S0018 MSI-m and MSI-mx replacement

The current MSI-m(E)/R and MSI-mx(E)/Rx series will be phased out by November 2024 without a direct replacement. Due to the large number of used MSI-m devices in the market, there is an option to use the Pizzato CS MP306MO device with pre-programmed software as a replacement. The necessary rewiring is shown in the following tables.

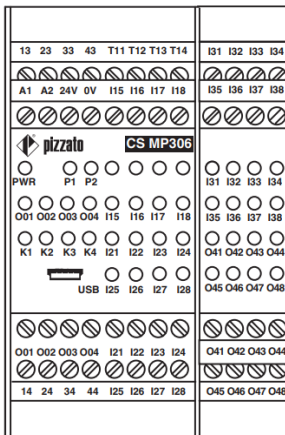
<b>NOTICE</b>	
	<p>MSI-m/R does not have clamps 16, 17, 25, 26, 34 and 35, so Pizzato CS MP306MP has to be rewired:</p> <ul style="list-style-type: none"> <li>- I23 and I24 have to be connected with 24 VDC</li> <li>- I15 and I17 have to be connected with T11</li> <li>- I16 and I18 have to be connected with T12</li> </ul>

<b>NOTICE</b>	
	<p>Please, note the different logic of the EDM – I37. 24 VDC must be used for activation the EDM and not 0 VDC as in the previous solution.</p>

MSI-m/R legacy with four sensor parallel - Muting  
Observe the operating instructions for the components!

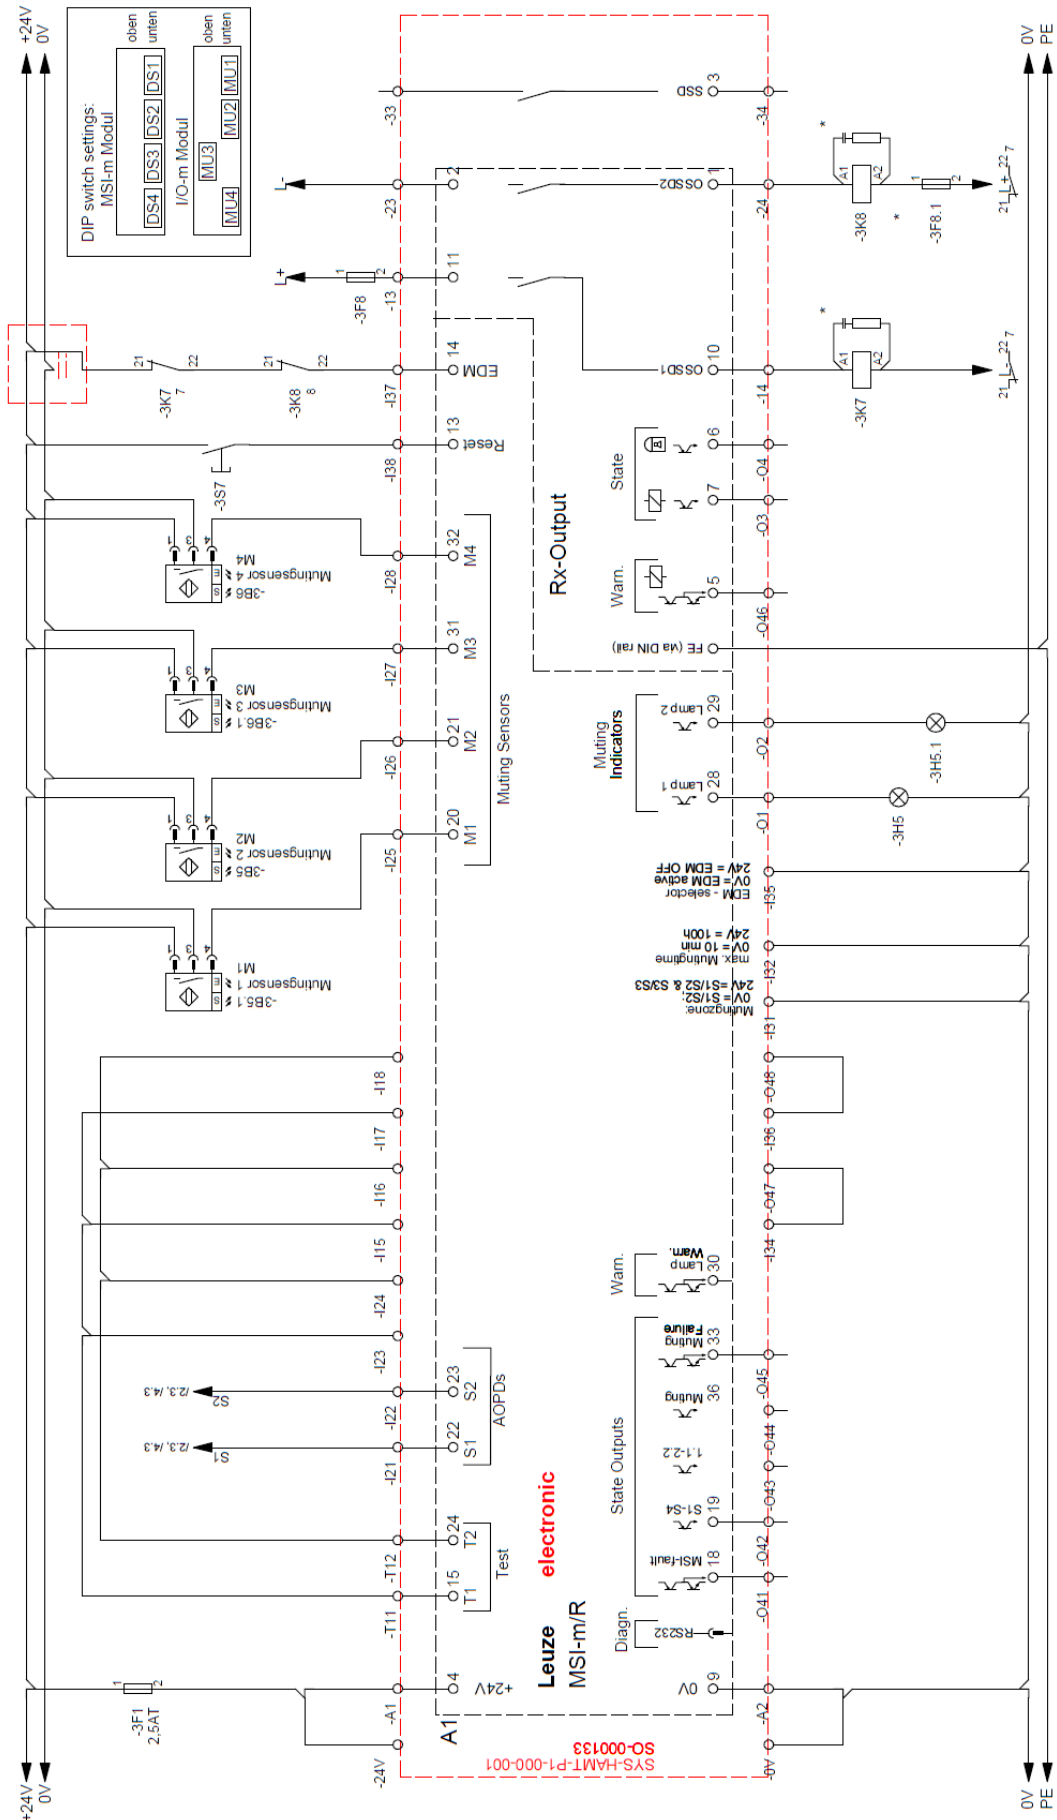
# Pizzato version for MSI-m/R connection

MSI-mx/Rx legacy with two times two sensor X - Muting  
Observe the operating instructions for the components!

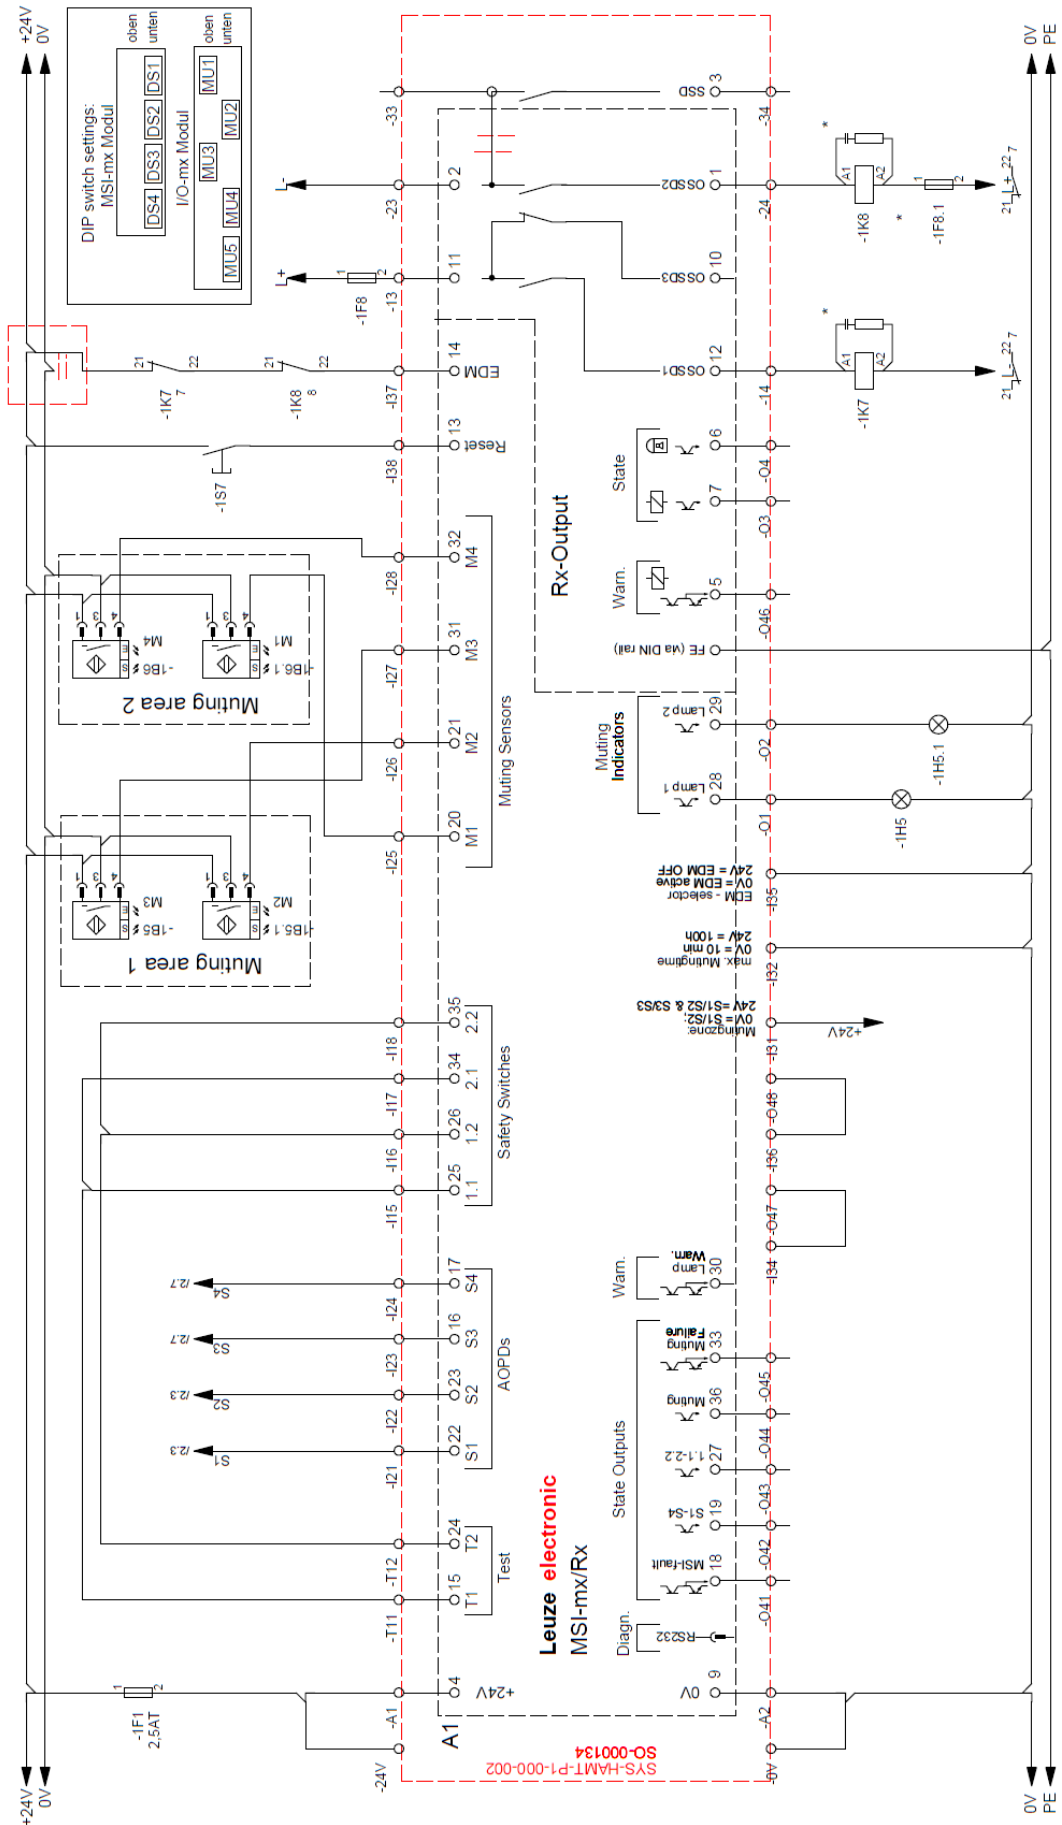
# Pizzato version for MSI-mx/Rx connection
